S/D 97-34 -- One-Step Preliminary Final Plat of RESTHAVEN GARDEN OF MEMORY

May 22, 1997 - Page 2

STAFF REPORT
(Final Plat, Preliminary Plat Approved 6/17/99)

CASE NUMBER: S/D 97-34 -- RESTHAVEN GARDENS OF MEMORY ADDITION

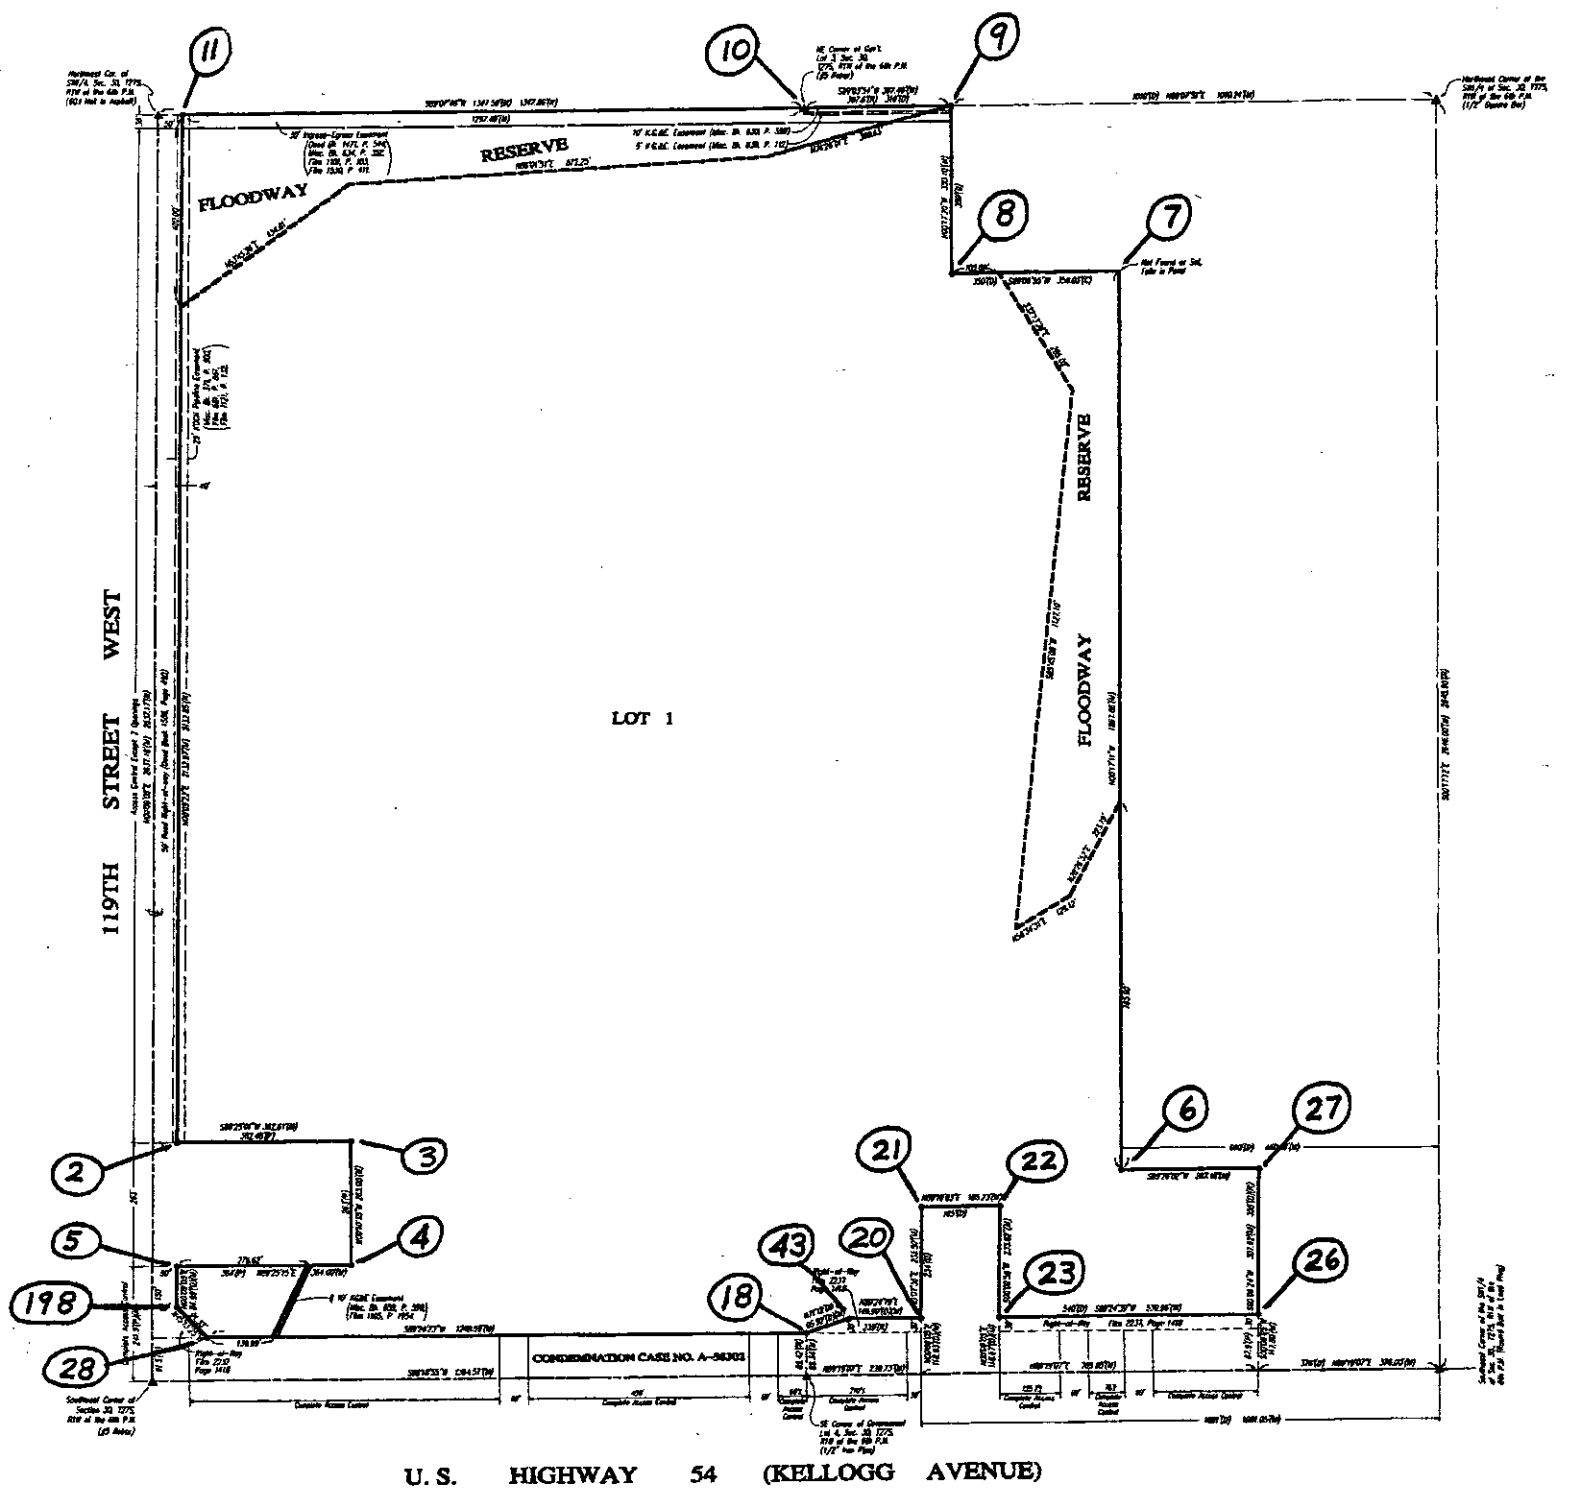
- B. As shown, no block or lot numbers have been indicated and it is unclear how the administration and maintenance tract is to be treated. Is it to be included in the overall lot and block for the rest of the cemetery or is it a separate lot/block. The same with the mausoleum.

- C. The tracts for the mausoleum and the administration and maintenance lots are land locked with no means of access shown, unless the entire tract is served by private drives.

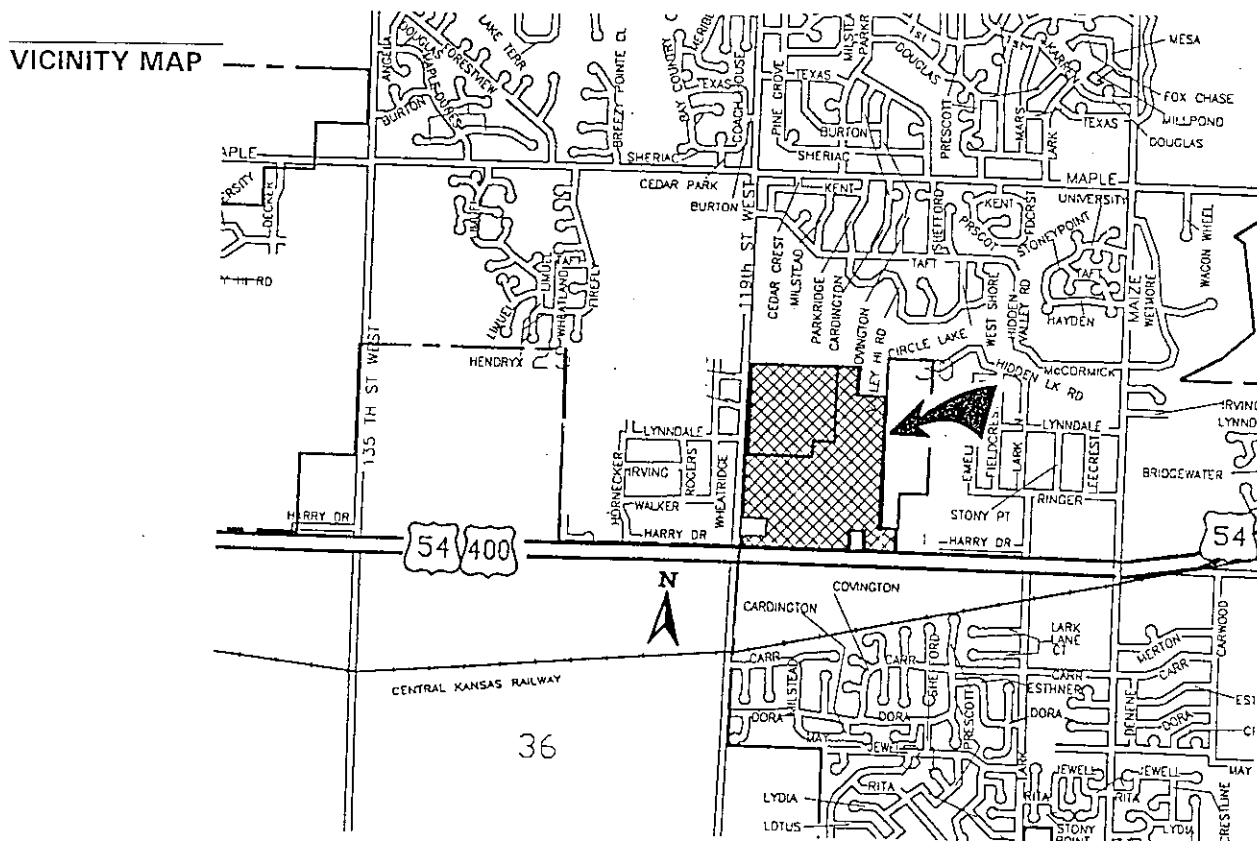
- A. City Engineering needs to comment on the need for guarantees and easements. *A petition is required for both City water and sanitary sewer; the sewer petition to be held until future need arises.*

- C. City Engineering needs to comment on the status of the applicant's drainage plan.
- D. Traffic Engineering needs to comment on the need for access controls. The applicant proposes four access openings along Kellogg and two openings along 119th St. West. Traffic Engineering has advised the applicant that the four openings along Kellogg will connect to the one way proposed frontage road and access will be limited to right in and right out movements. The plat's text should note these access controls as being contingent upon construction of the frontage road.

- E. Traffic Engineering needs to comment on the need for any additional right-of-way for perimeter streets. Traffic Engineering has required 75-ft of half street right-of-way along 119th St. West for a distance of 175 feet north of the Kellogg right-of-way line, then tapering to 50 feet in width at a distance of 275 feet north of the intersection. The right-of-way on the southwestern corner of the plat shall consist of a 60-ft radius connecting the 119th St. right-of-way line and the Kellogg right-of-way line.

The final plat has included the requested right-of-way.
- F. The plat's text shall include language that a drainage plan has been developed for the plat and that all drainage easements, rights-of-way, or reserves shall remain at established grades or as modified with the approval of the applicable City or County Engineer, and unobstructed to allow for the conveyance of stormwater.
